**PLANNING COMMISSION MEETING  
STAFF REPORT  
MONDAY, MARCH 18, 2024**

**CASE NO:** PC 24-0004  
**PROJECT NAME:** MSD ADMINISTRATION BUILDING  
**PROJECT ADDRESS:** 1009 FAIRFAX AVENUE, RIVERSIDE, OH 45431  
**PARCEL ID:** I39 00115 0014, I39 00115 0015, I39 00115 0023, I39 00115 0024, I39 00116 0013, AND I39 00116 0014  
**APPLICANT/PROPERTY INFO:** GREG DAVIS, G. DAVIS CCM  
5733 WEST FORK RD, CINCINNATI, OH 45247  
**OWNER/PROPERTY INFO:** JOHN STEWART, MECHANICAL SERVICES AND DESIGN,  
4401 SPRINGFIELD ST, DAYTON, OH 45431  
**ZONING DISTRICT:** B-2 GENERAL BUSINESS DISTRICT  
**CURRENT USE:** VACANT LOTS

A site plan application to review a new one-story 26,000 sf office building on 1.2 acres and parking waiver to reduce the spaces from 67 to 55.

RE: Proposed MSD Office Building  
Site Plan Application  
TRC Review Comments  
Springfield Street  
Parcel No.'s I39-00115-0023,0024,0014,0015  
I39-00116-0013,0014  
A&A No. 23-0088

**SITE LAYOUT PLAN**  
**PROPOSED OFFICE BUILDING, MSD, INC.**  
 SECTION-23, TOWN-2, RANGE-7  
 CITY OF RIVERSIDE  
 MONTGOMERY COUNTY, OHIO

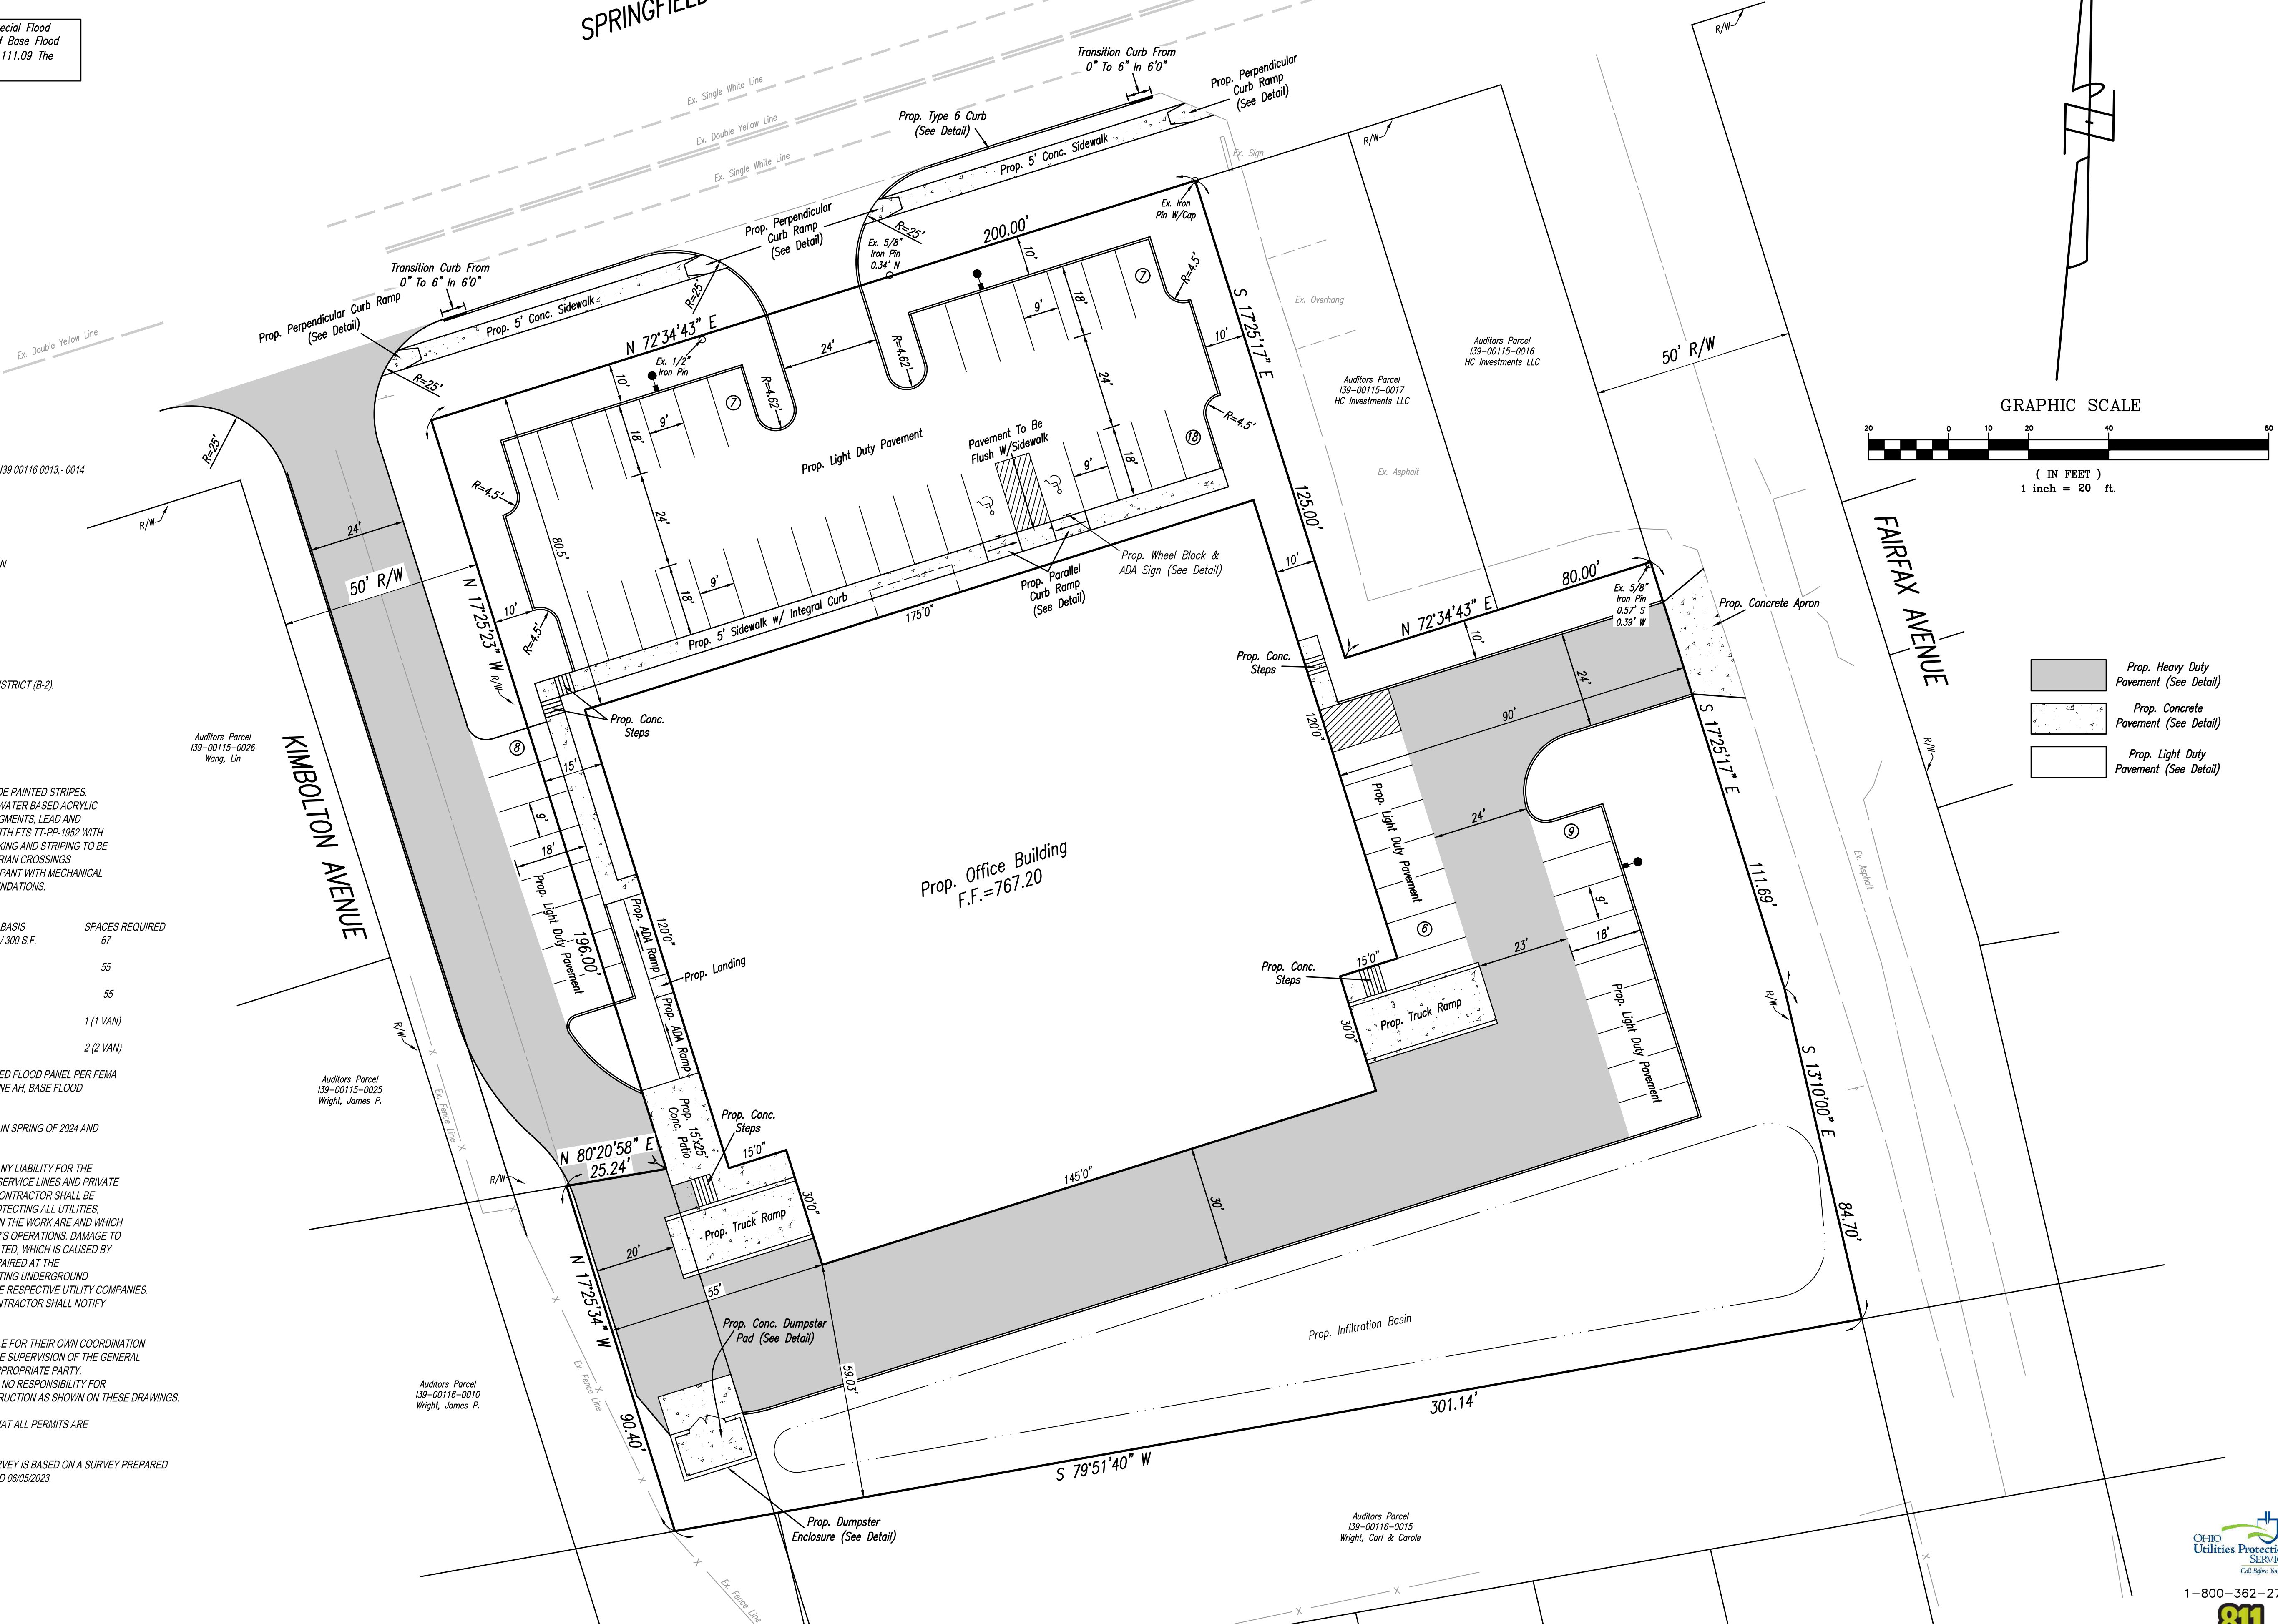
1. **Parking Waiver** – The applicant/owner is requesting a wavier to the zoning requirements for off-street parking. The proposed 20,000 s.f. office building will require 67 off-street parking stalls per the current zoning requirements. The attached revised plan reflects 55 off-street parking stalls, a minor 18% reduction in off-street parking. Please note the following reasons of justifications for granting a wavier to reduce the off-street parking for the above referenced office building:

- a. The request to reduce the amount of off-street parking is in spirit with the City's Comprehensive Plan "Explore and Encourage Shared Parking Agreements".

- b. MSD's existing facilities are located directly north of the proposed office building, along the north side of Springfield Street. The existing facility is proposed to remain and will provide additional shared parking for company employees.

- c. The proposed parking located in the front of the proposed office building will serve visitors and patrons of the company. Based on past years of being in business the owner can confirm that the amount of off-street parking proposed will suffice the business parking needs for visitors and patrons of the company.

- d. Based on the fact that additional shared parking will be available across the street at the existing MSD facility as stated in item (b) above, the adjacent or nearby properties will not be affected.
